**Broadlands Water Booster Pumping Station
Phase III Upgrade
Project ID Number 2007-0164
RFQ 2011-018-200**

ADDENDUM 1

Addendum Issued: January 26, 2012

PROJECT: Broadlands Water Booster Pumping Station Phase III Upgrade
Project ID Number 2007-0164
RFQ 2011-018-200

ELECTRICAL EQUIPMENT RACK DETAIL

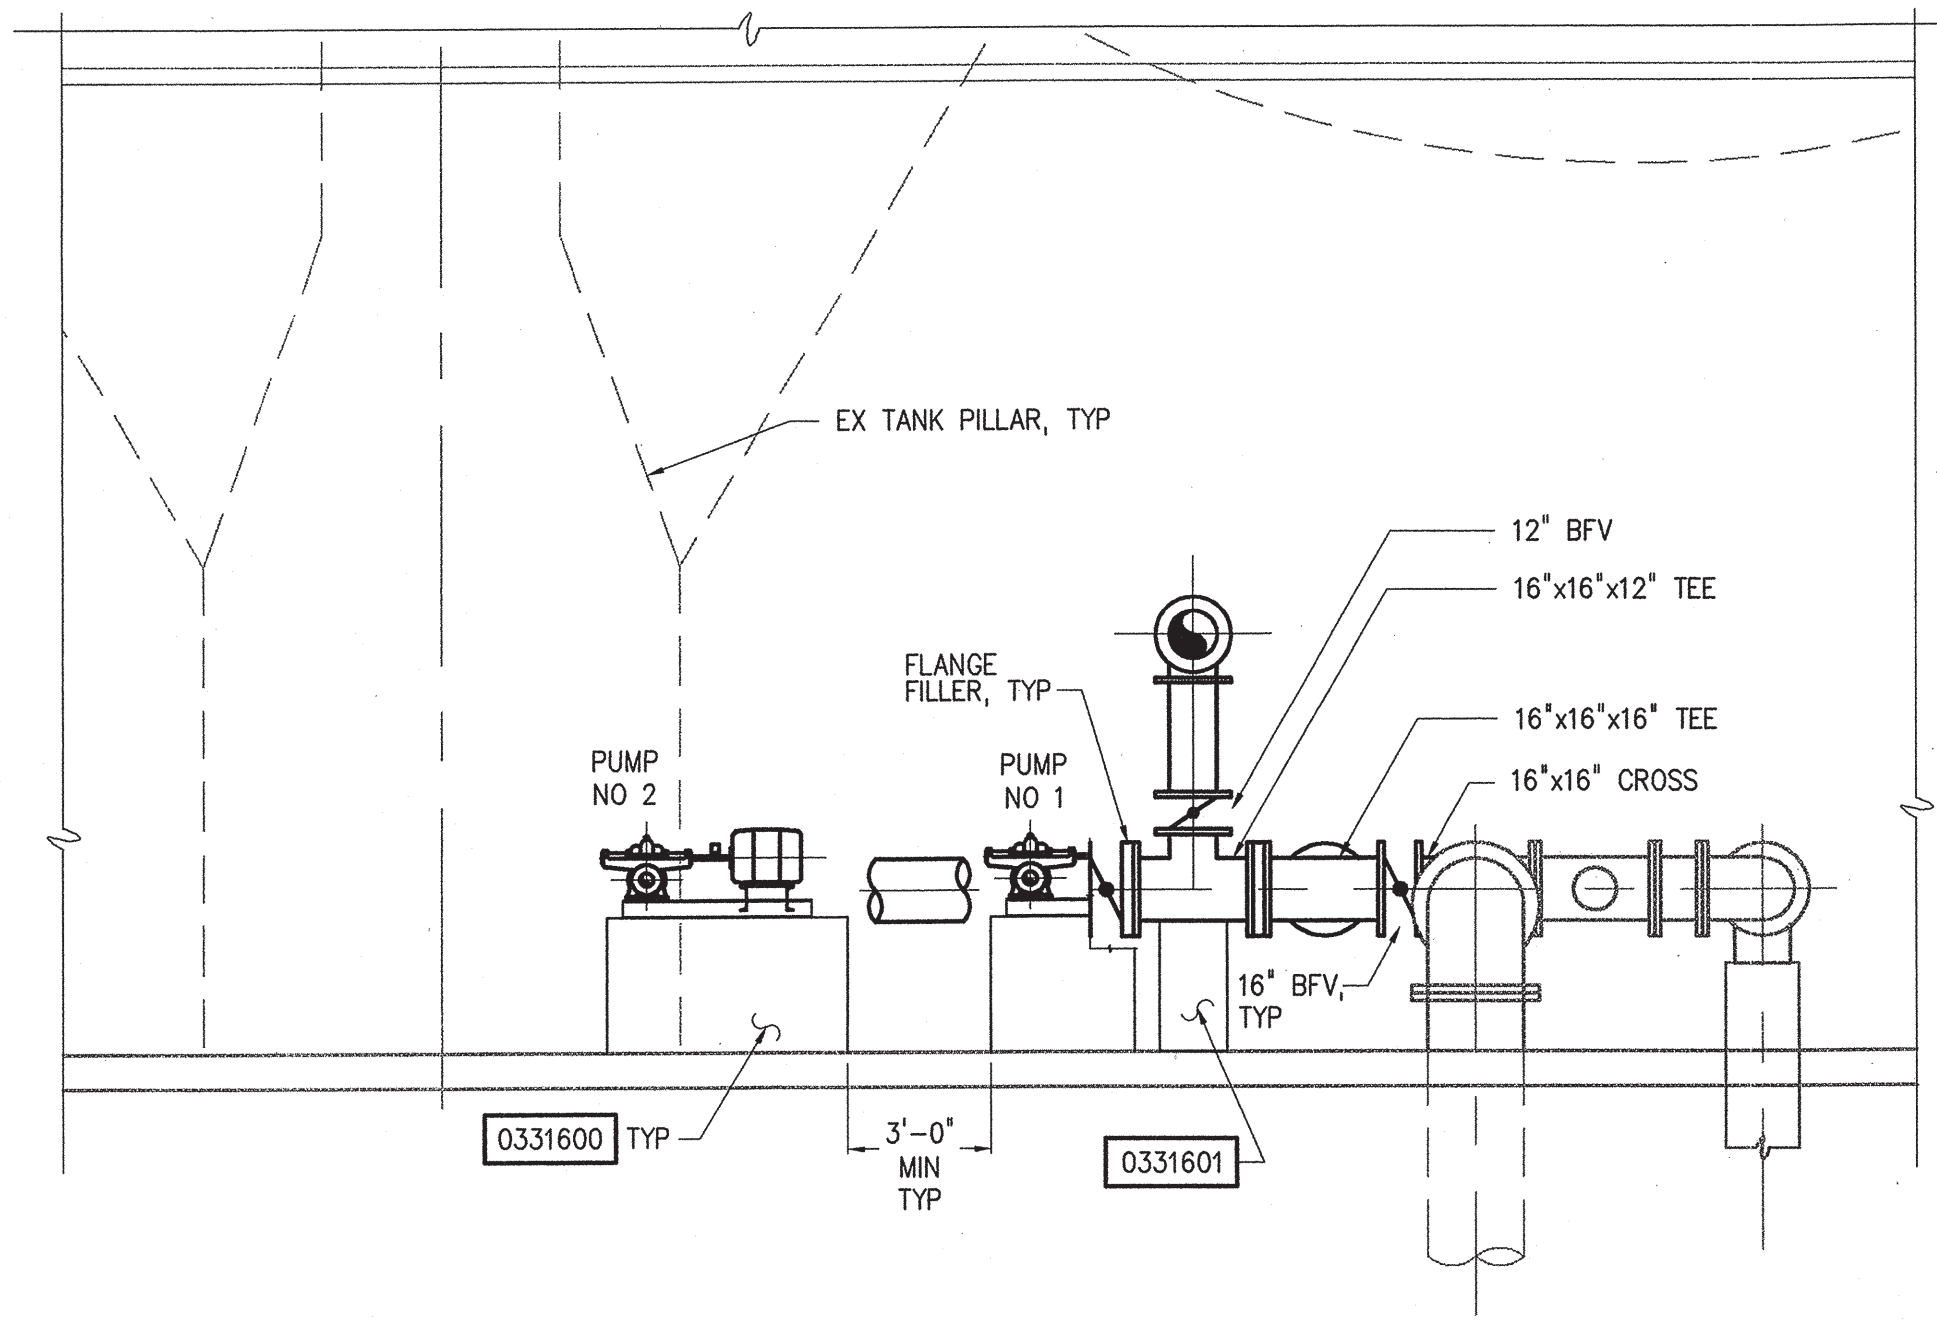
Question 7: There is a plan notation to provide 4' x 8' x 1/4" steel backboard at the locations for the manual transfer switch and VFDs. The VFDs are replacing existing starters which are presently mounted on channel and appear to be adequate for the VFDs. Is it necessary to replace this channel with steel backboard? (Other backboards in the area are 3/4" plywood).

Question 8: Can the VFD and manual transfer switch equipment racks be free standing instead of wall mounted?

Plywood is not acceptable; Loudoun Water will only accept steel or aluminum backboards. See Attachment #3 - equipment rack.

Yes, see Attachment #3.

MECHANICAL
SECTIONS

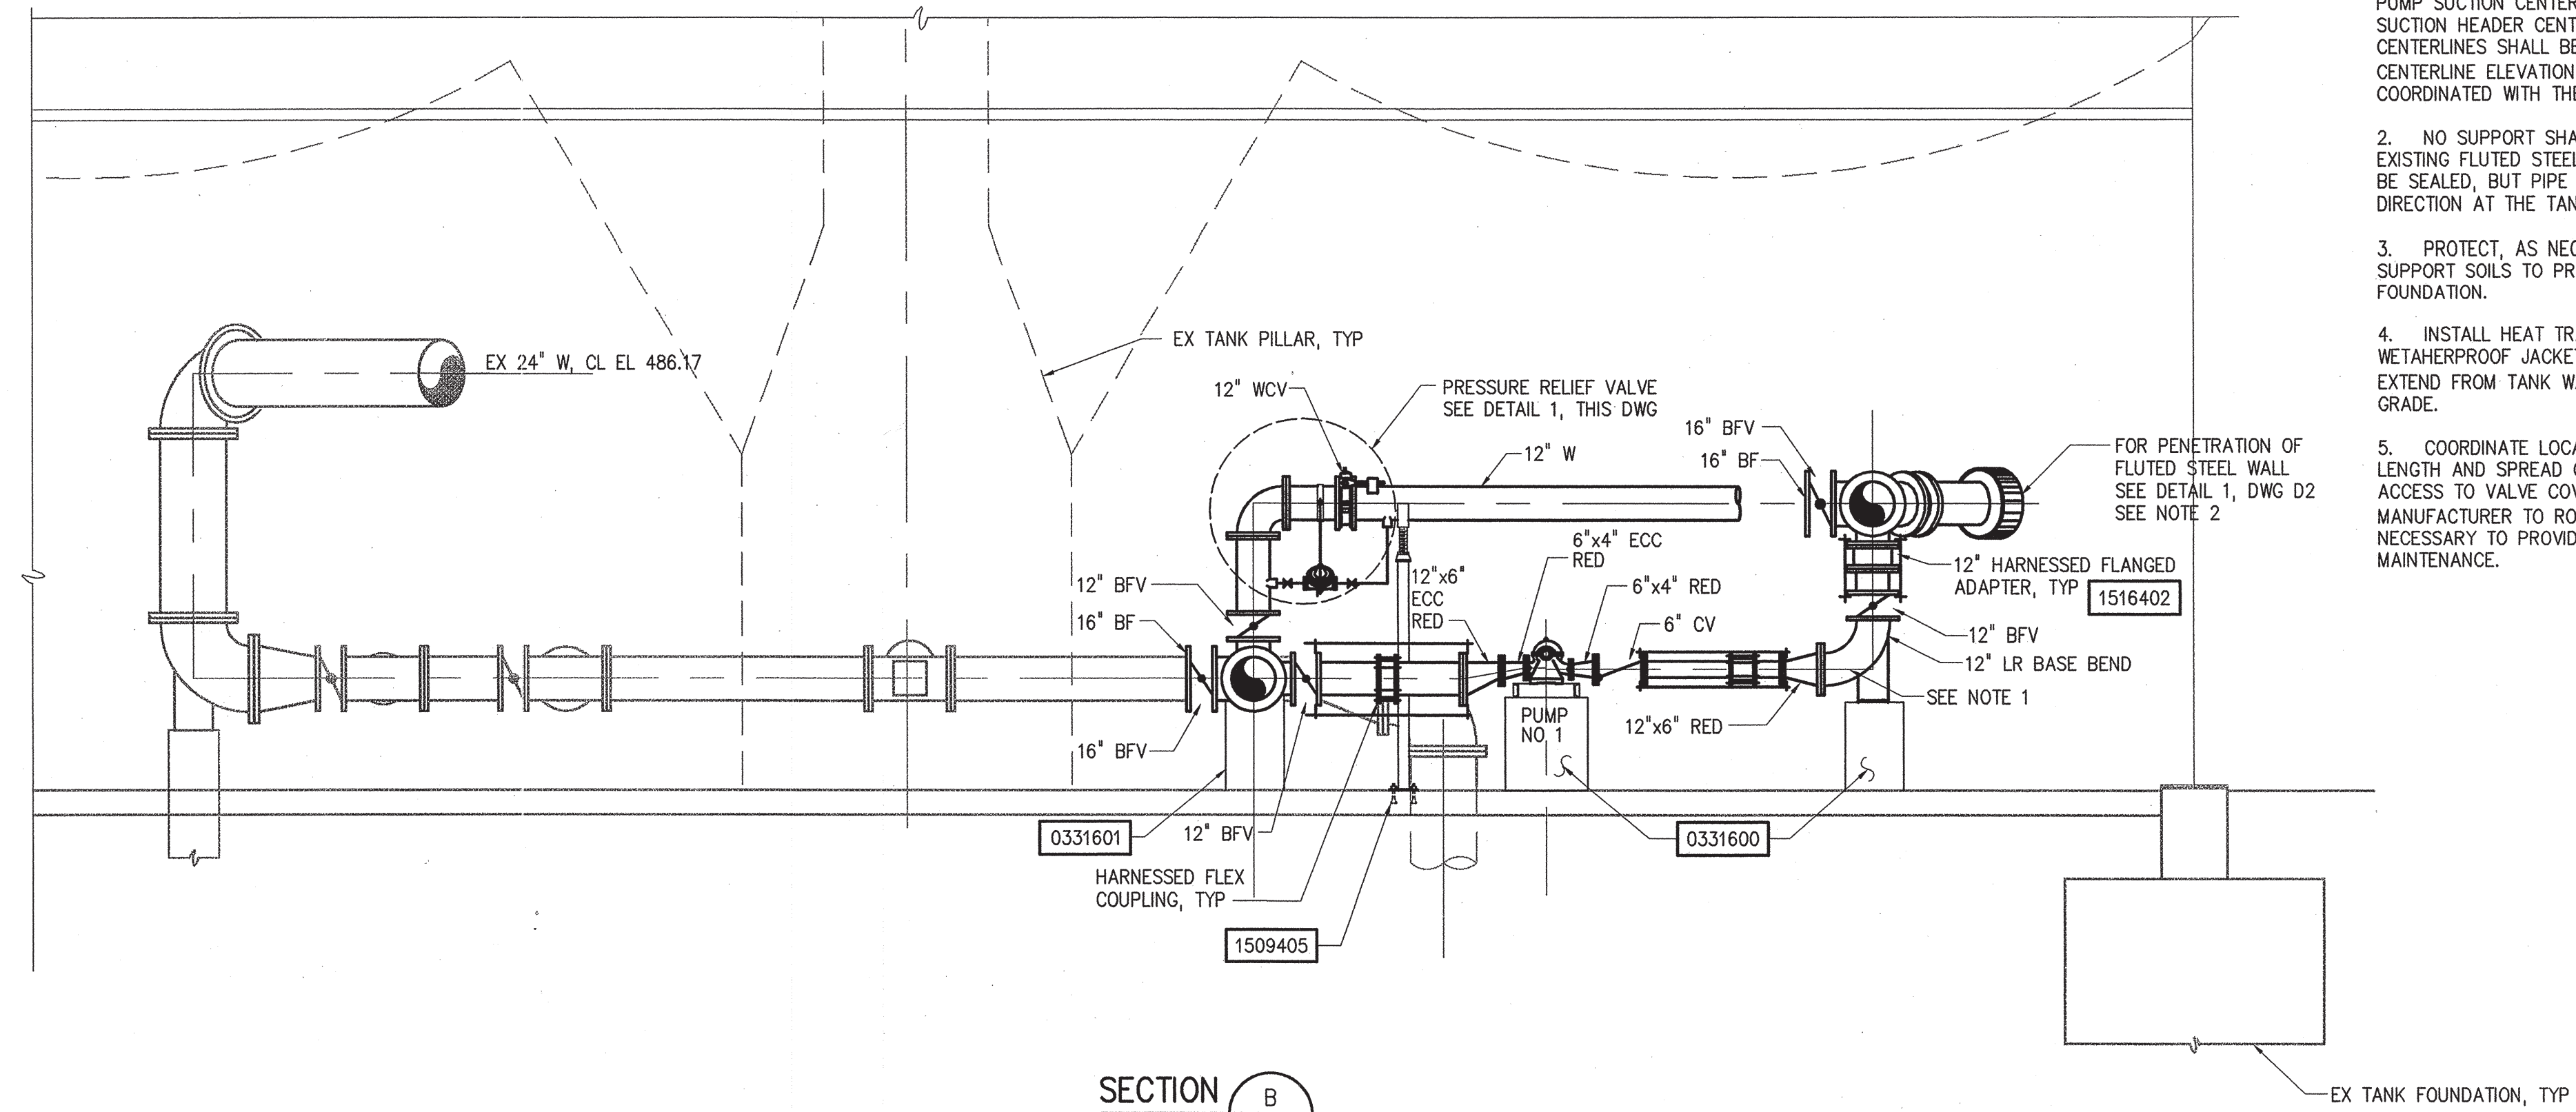
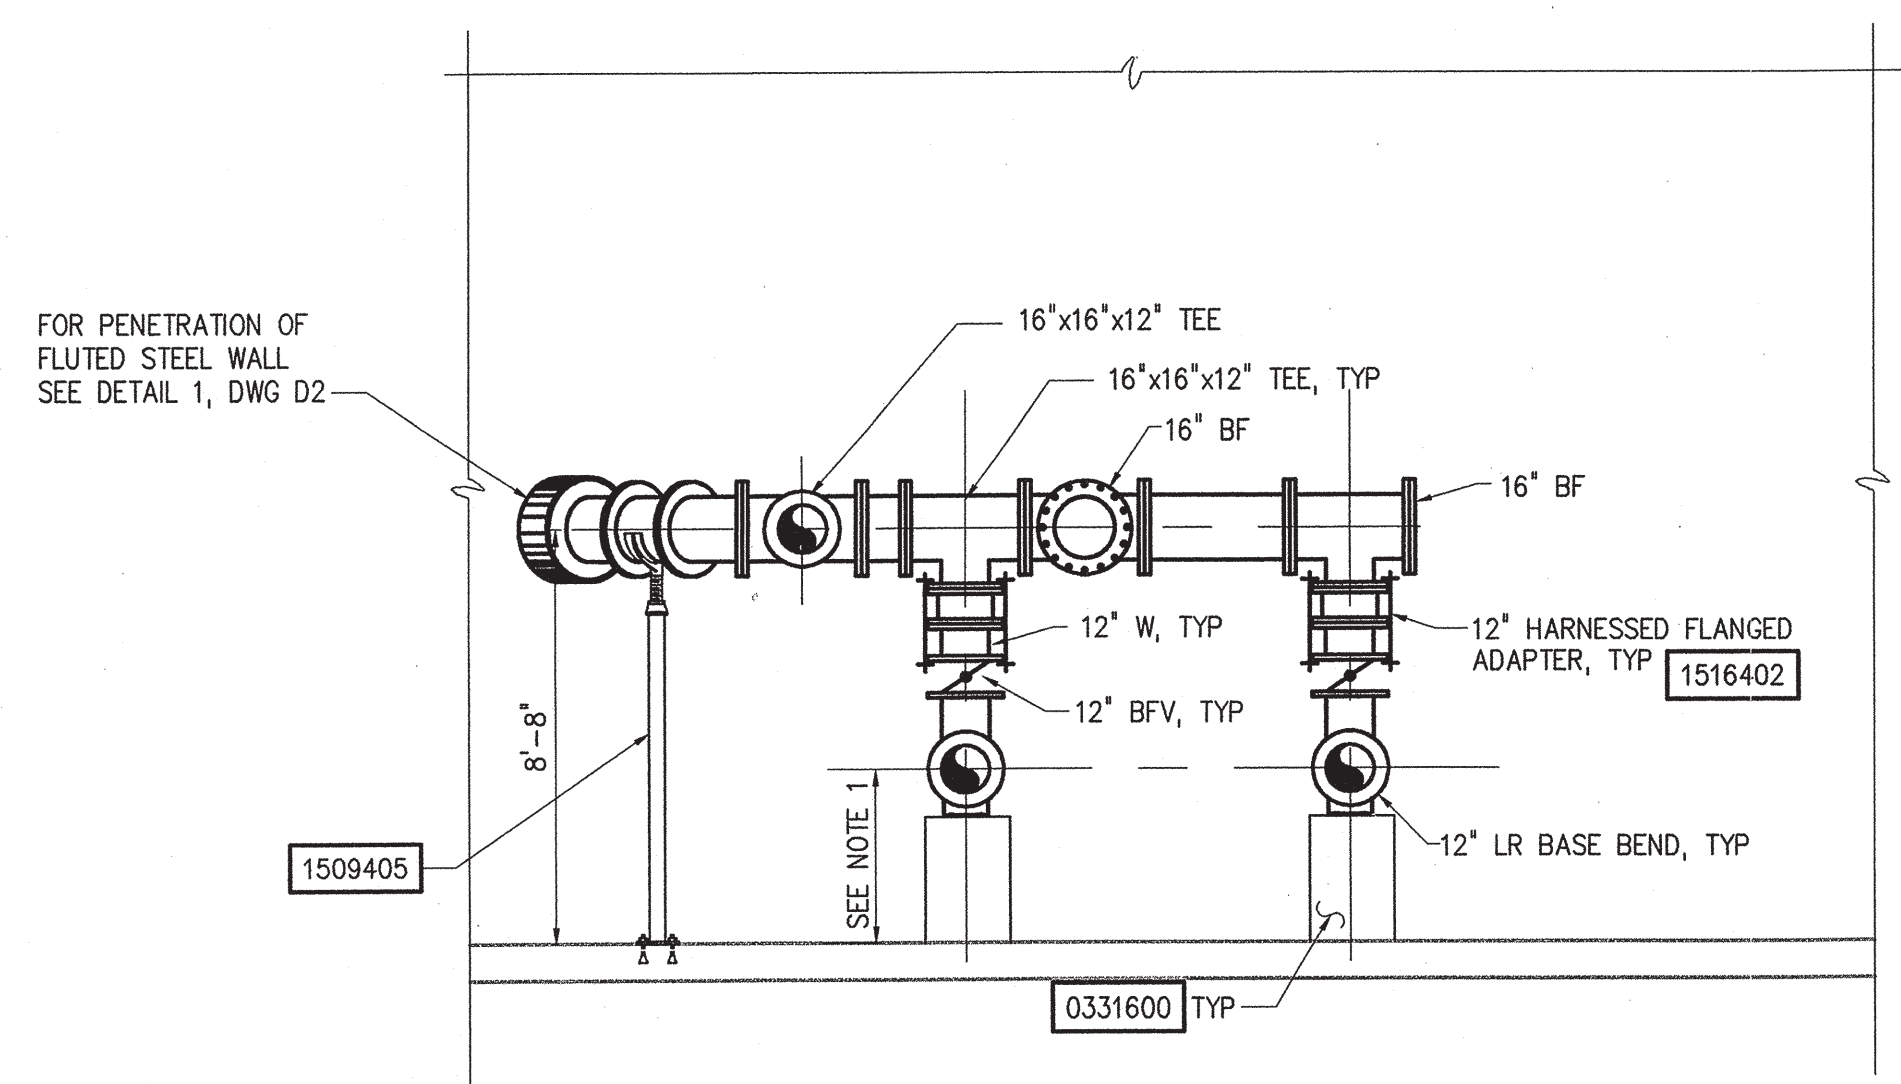
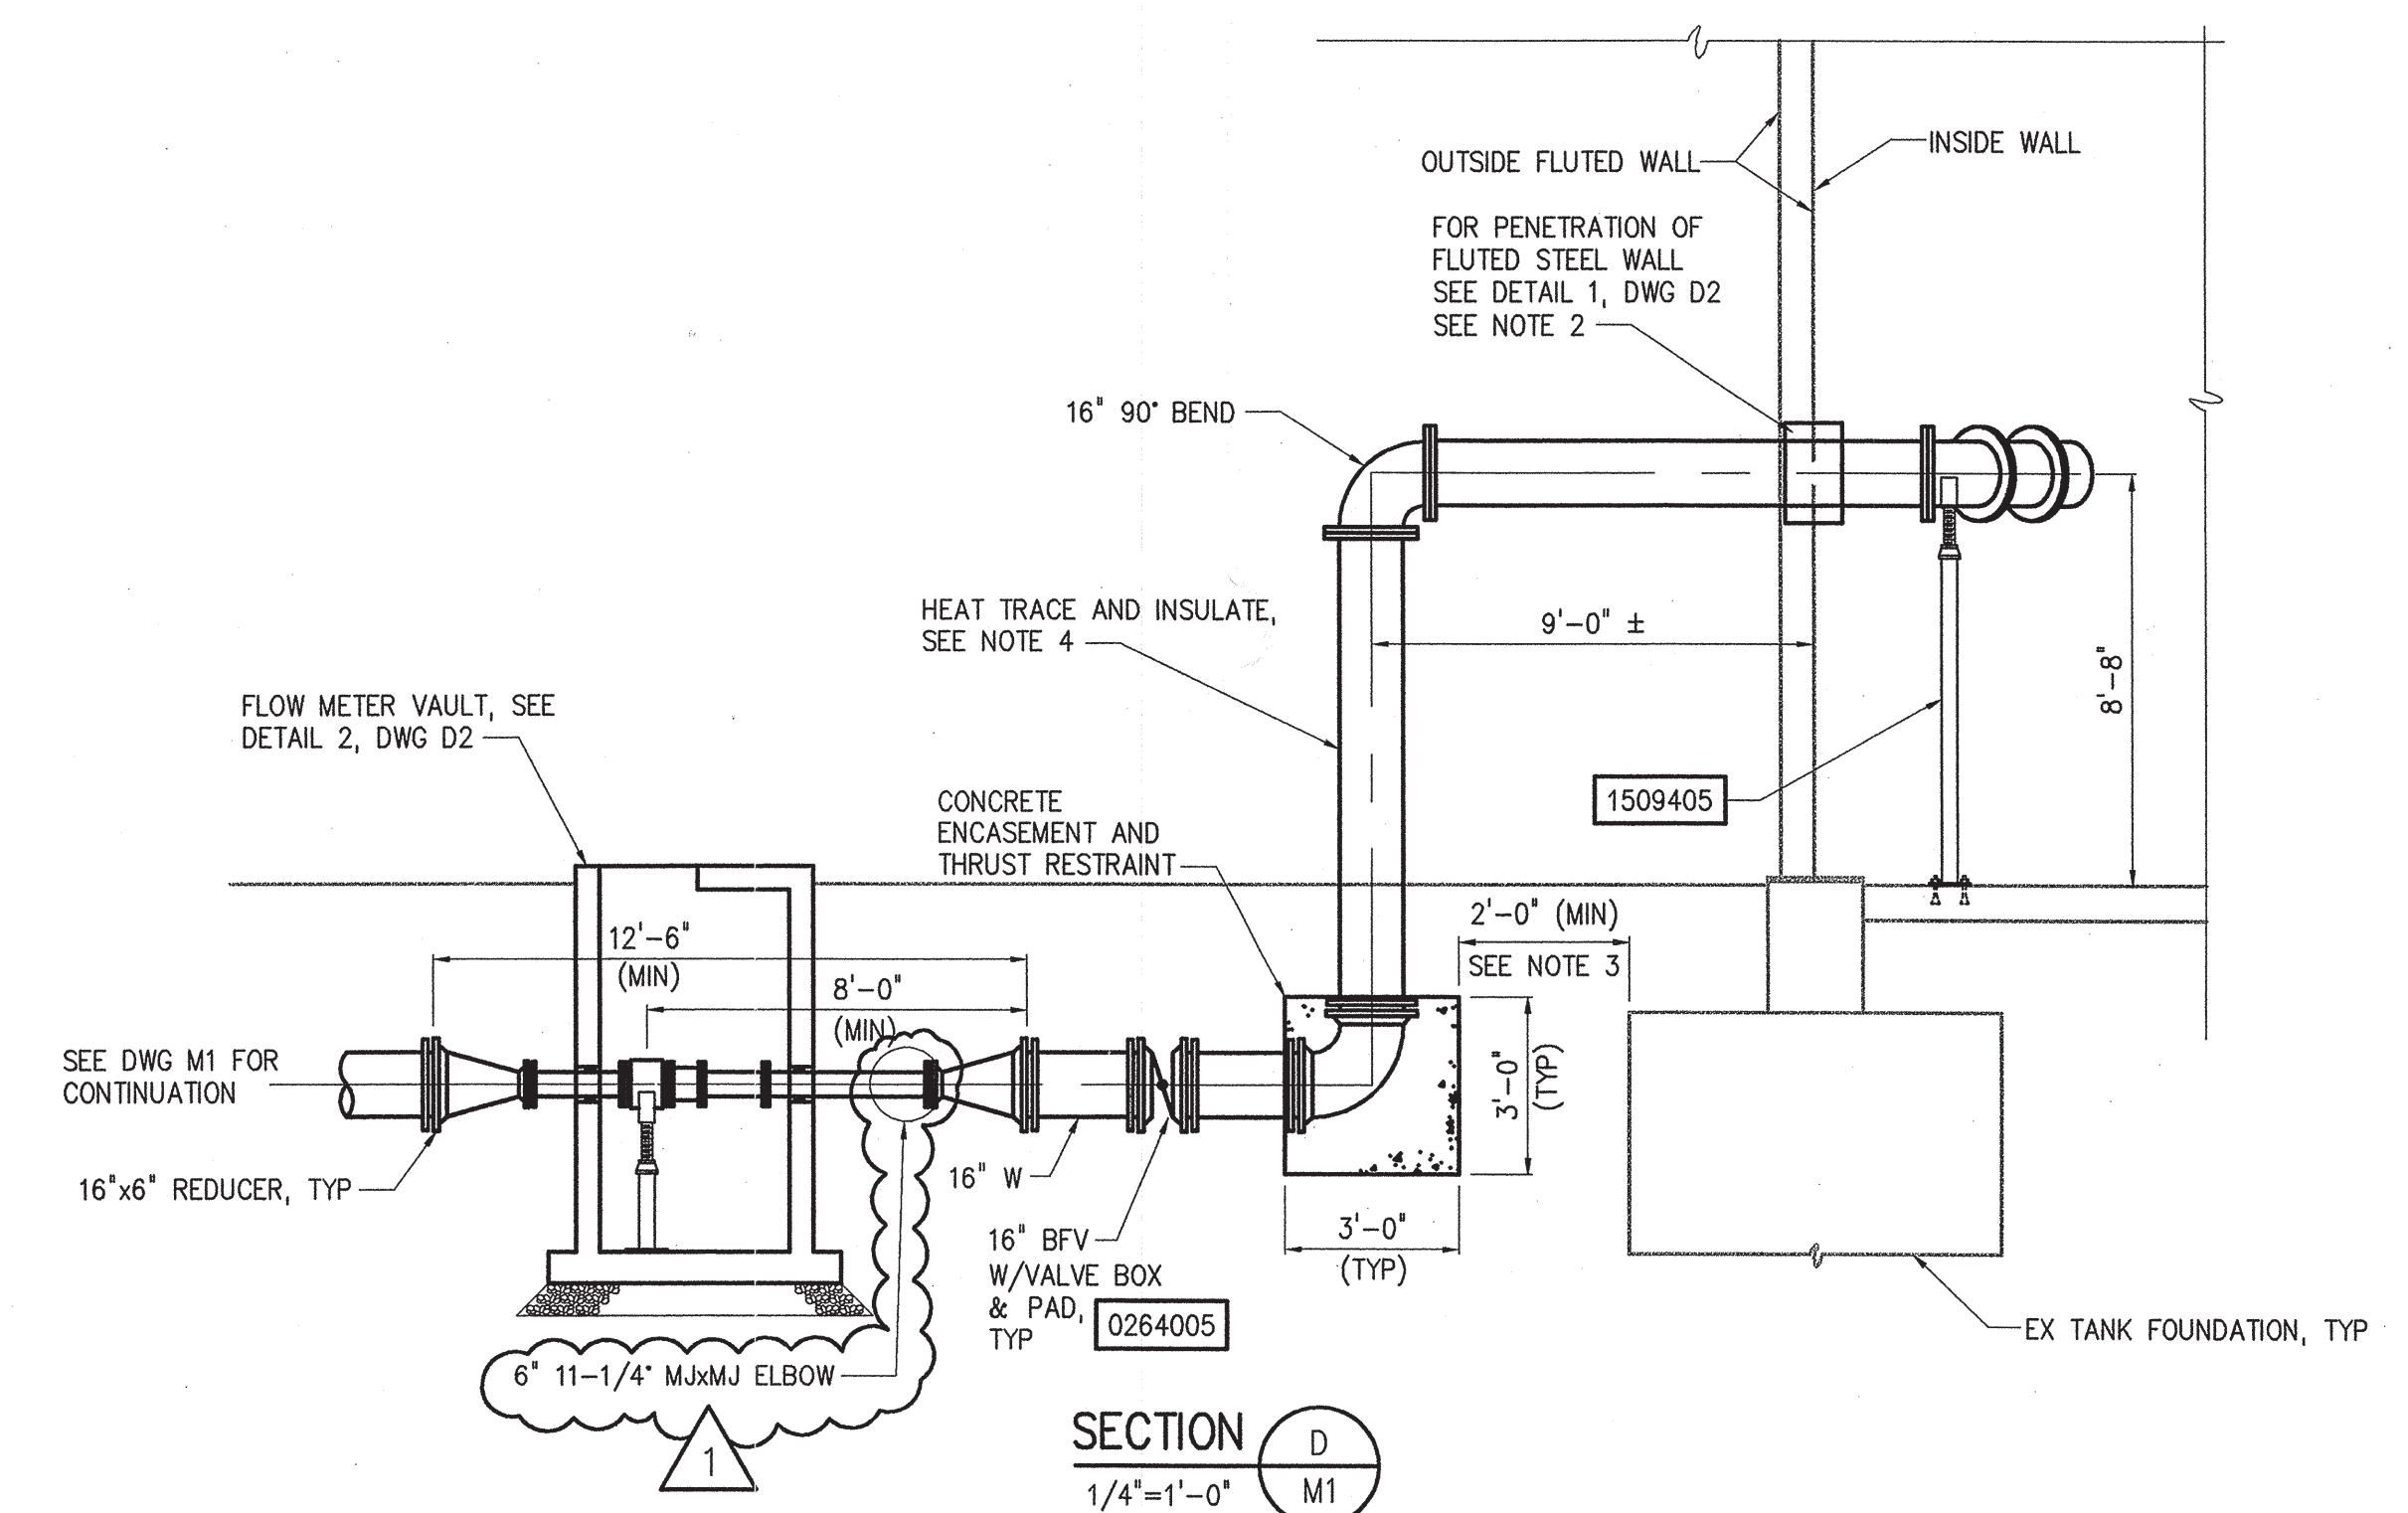
Question 1: Drawing Sheet no. 2 of 7 is missing in the file we downloaded off of the Loudoun Water site. Please provide this missing sheet.

See Attachment #4, Sheet No. 2. M2 - is provided for reference purposes only as no work is shown on this sheet.
